# UNITED STATES PATENT AND TRADEMARK OFFICE

10/777,809

<b>Office Action Summary</b>	<b>Application No.</b> 10/777,809	<b>Applicant(s)</b> LEWIS, ANTHONY GORDON	
	<b>Examiner</b> David T. Fidei	<b>Art Unit</b> 3728

## DETAILED ACTION

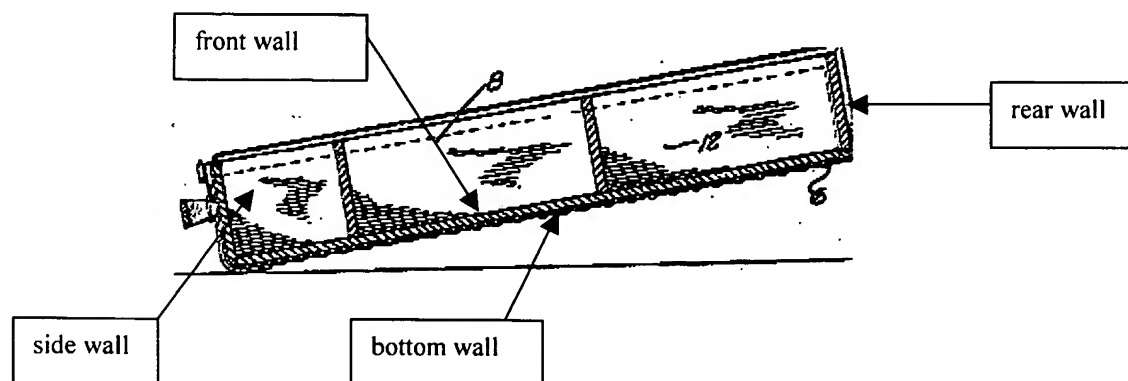
11. Claims 1, 2, 4, 5, 7, 9-18 are rejected under 35 U.S.C. 102(b) as being anticipated by Ritter, Jr. (US Patent no. 1,796,962). A portable display container is disclosed comprising an apparatus comprising a container 8 and a cover 7 in as much as is claimed. Any of the surfaces of section 8 comprises a surface for holding an electronic device in a much as applicant chooses to set forth.

As to claims 2, 4, 5, 7 it is a matter of convention as to what one considers a front, rear, bottom and sides walls in Ritter, Jr. As depicted below, a “front” is considered as that wall defined on the outside of section 8, the opposite side is considered the “rear wall” with the “bottom wall” defined at the right with the remaining peripheral walls defining “side walls”.

As shown above, three compartment are defined by the transverse wall extending upward from the front wall, as per claims 9-11.
